Your Comment on the Lodestone Energy Limited- Application for Haldon Station Solar Farm Proposal

RMA261598 – Lodestone Energy Limited Fast Track Proposal

Haldon Solar – Haldon Station, Mackenzie Basin

Section 53 Panel invite to comment on substantive application

Map 1: The proposed solar farm footprint and layout as presented by Figure 3 of the Ecology Report (Page 7). Lower image shows solar array layout in greater detail illustrating gaps between panels which may mitigate the risk of bird strike.

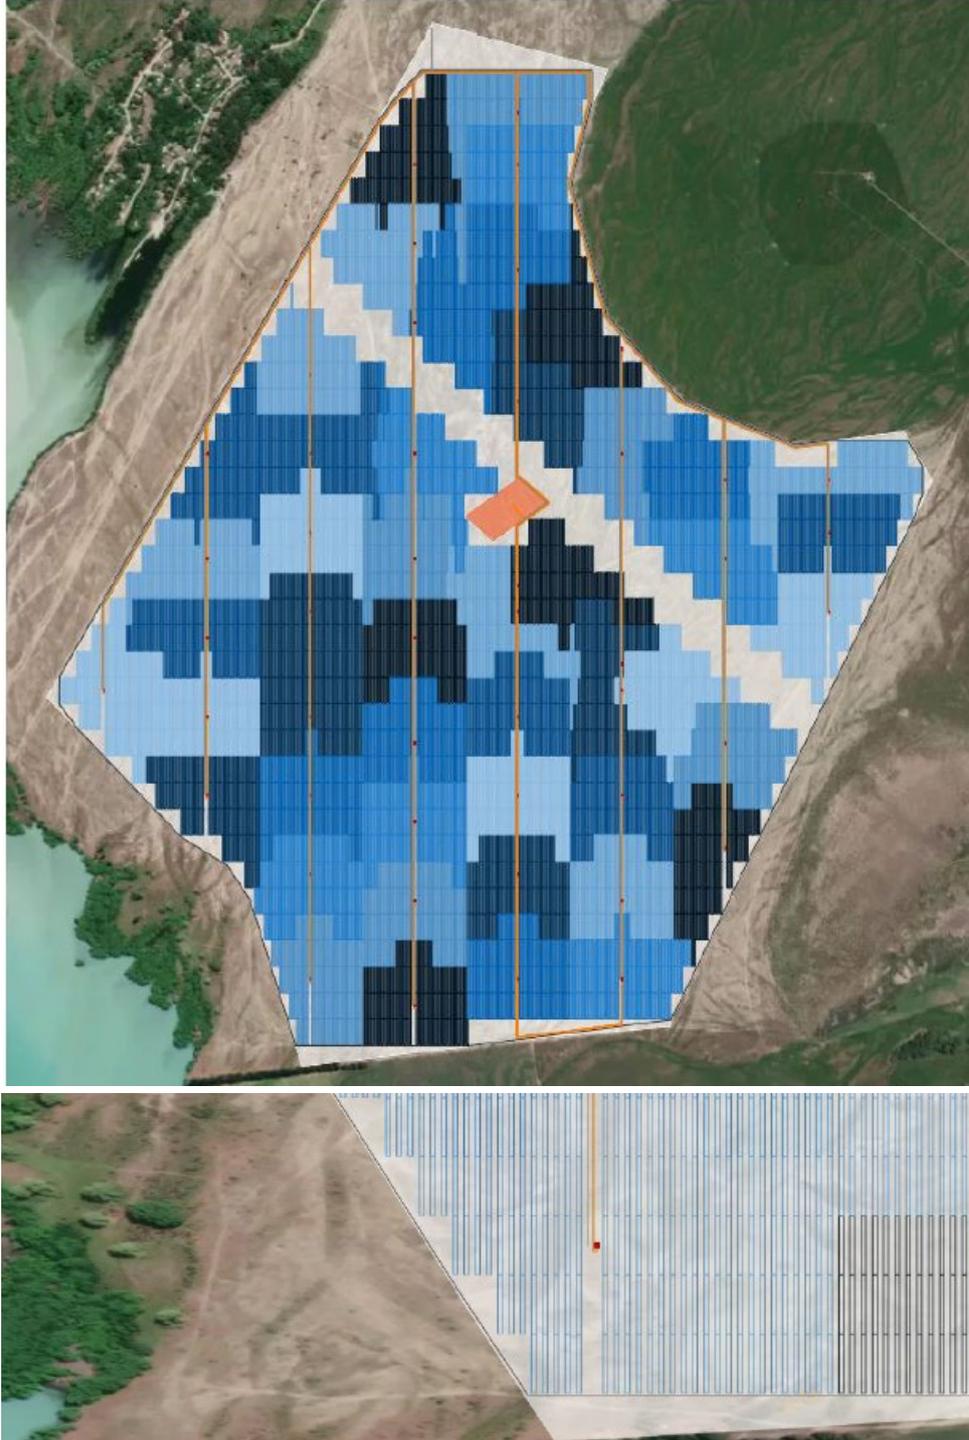
2. The proposed solar farm will alter environmental conditions of 320ha of ecologically significant dryland habitat. These changes will favour exotic plant species and exclude / reduce the abundance of native dryland species. This will result in unavoidable residual effects for which compensation and offsets would be required.

- II. Changes to soil moisture gradients; shading and stormwater management will transform environmental conditions of 320ha of ecologically significant dryland habitat. These changes will favour exotic plant species and exclude / reduce abundance of native dryland vegetation and, potentially, the associated fauna.

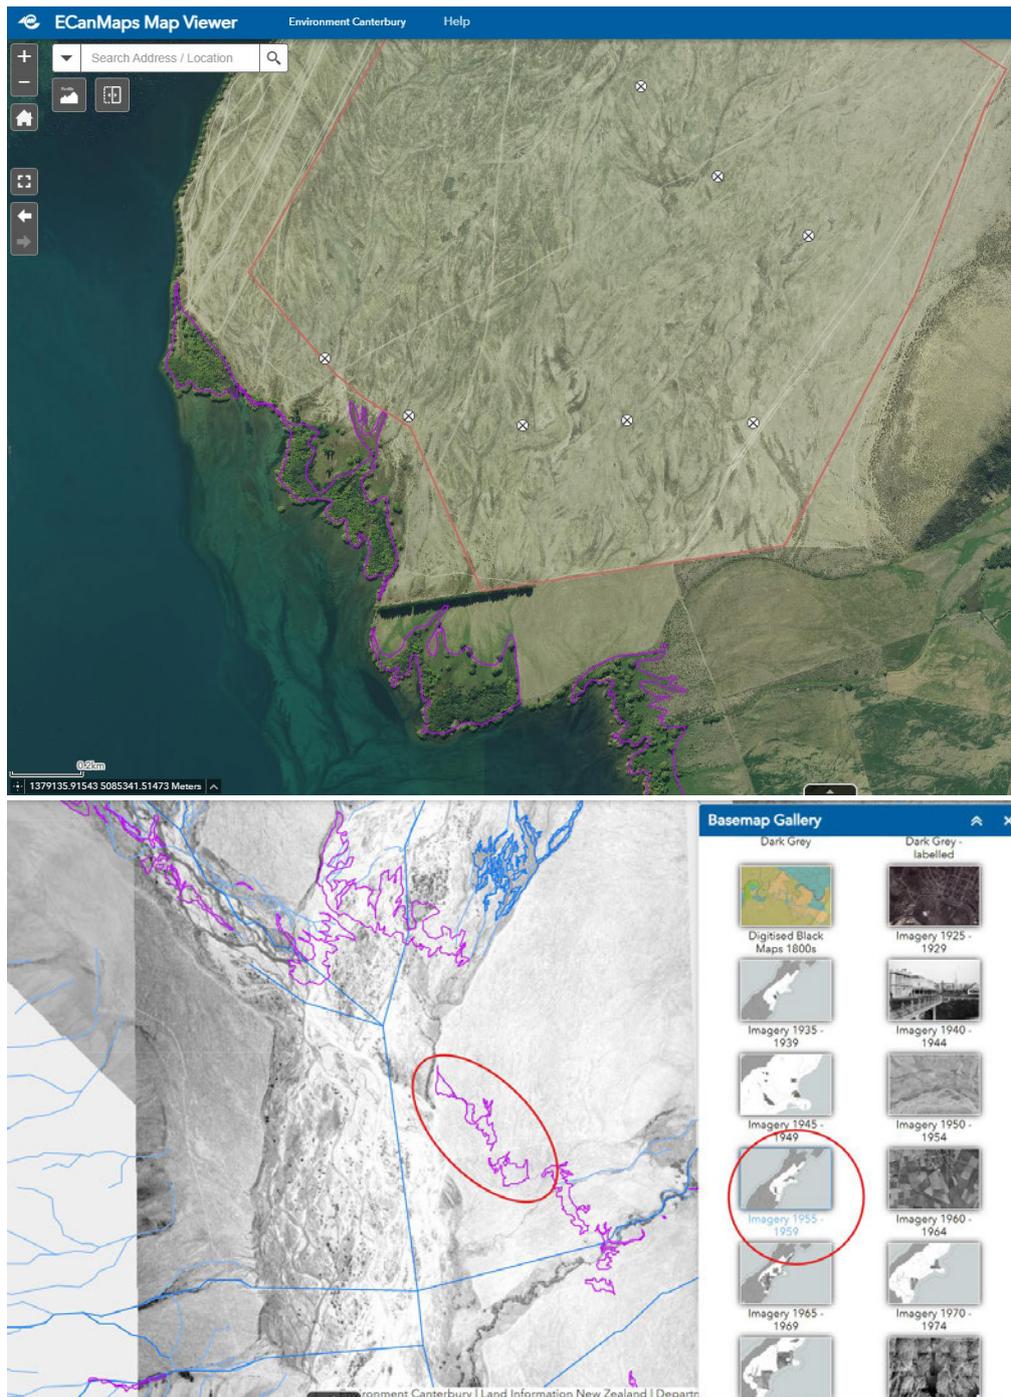
Statement for Freshwater 2020 as they have been induced by the constructed waterbody of the lake. However, they may provide habitat to indigenous fauna and thereby warrant consideration for potential effects of the proposal (see below fauna considerations).

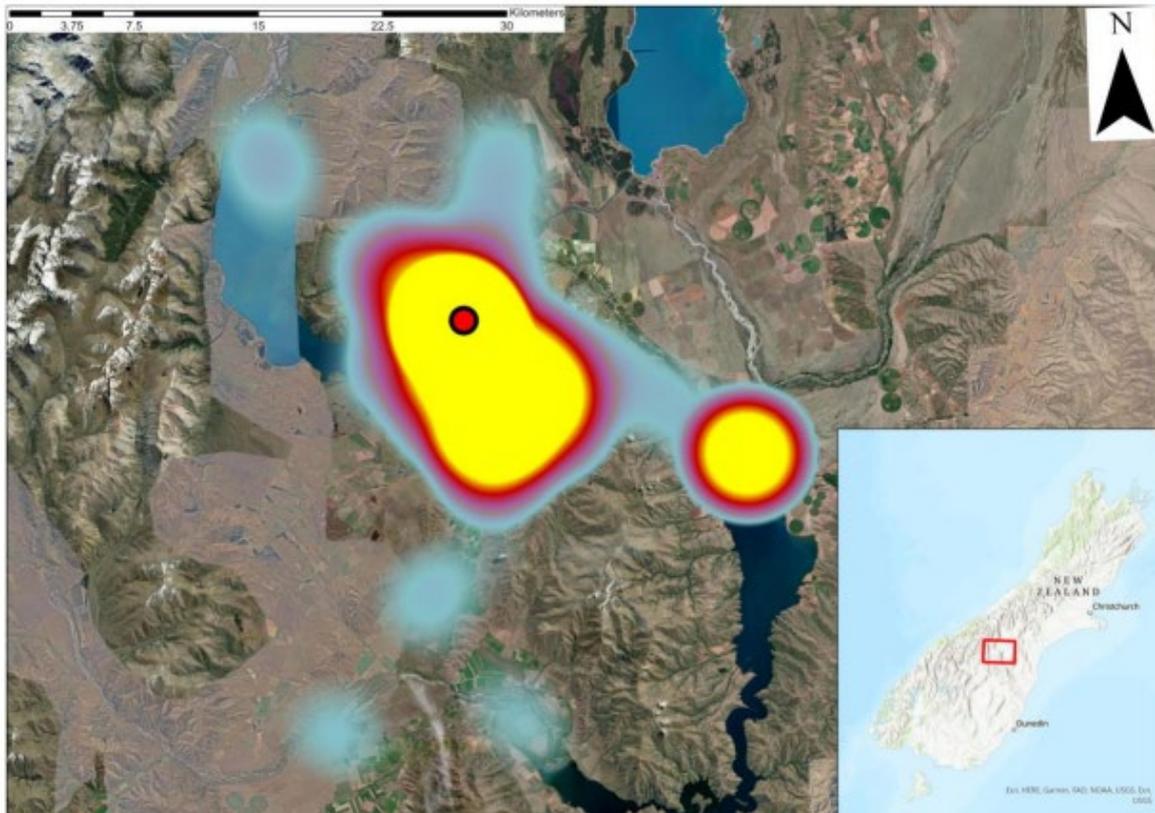
56. The site is located at a hot spot for Nationally Threatened and At-Risk bird species which frequent the Ohau-Tekapo river delta at Lake Benmore. Flight paths of these birds are known to traverse directly across the proposed solar farm site. This is known in detail for at least one species – black fronted tern - from recent research which placed transmitters on birds' flight revealing their flight routes³¹ (see **Attachment 4**).
